DATE: 2023-04-13

MODEL: SR3XX

STEERING WHEEL DISPLAY ISSUES

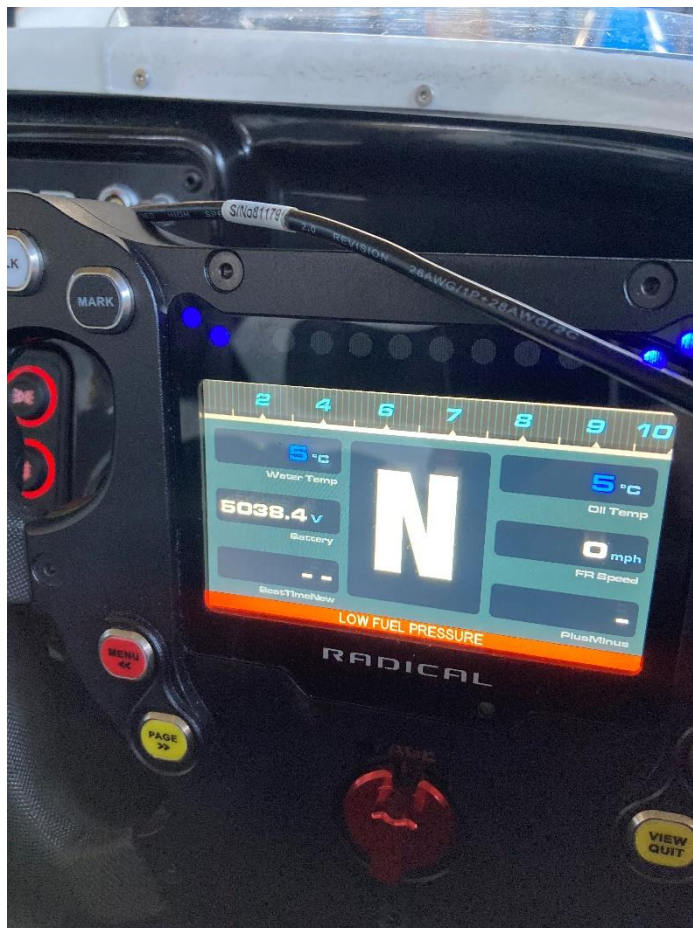
A bug has been found in the Aim software which can cause the voltage and oil pressure value to be displayed incorrectly on the steering wheel display. See below example:

To rectify this issue, please load PDM32-SR3-XX-v14 config.
